IREDELL COUNTY HEALTH DEPARTMENT

IMPROVEMENT PERMIT / AUTHORIZATION TO CONSTRUCT / OPERATION PERMIT / EXISTING SYSTEM INSPECTION

PERMIT# 88255 PIN# 4765035734

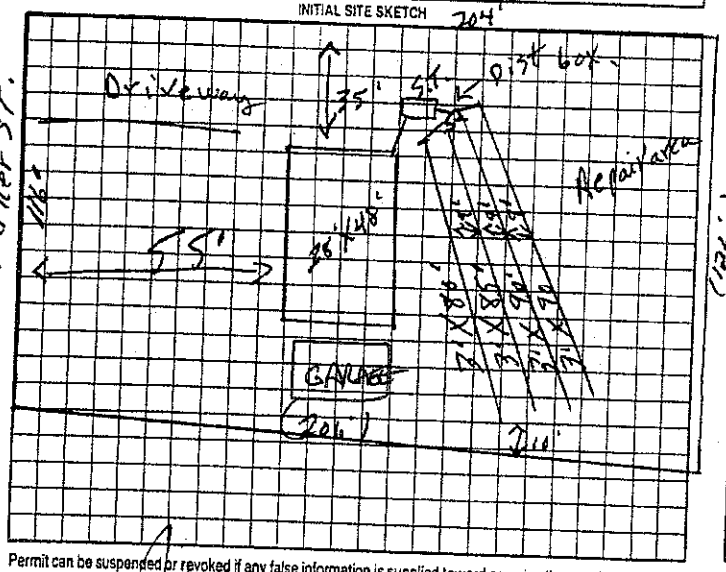
Location of the proposed DETACHED GARAGE addition does not appear to impact the existing on-site septic system.NOTE: KEEP MINIMUM 5' FROM SYSTEM**
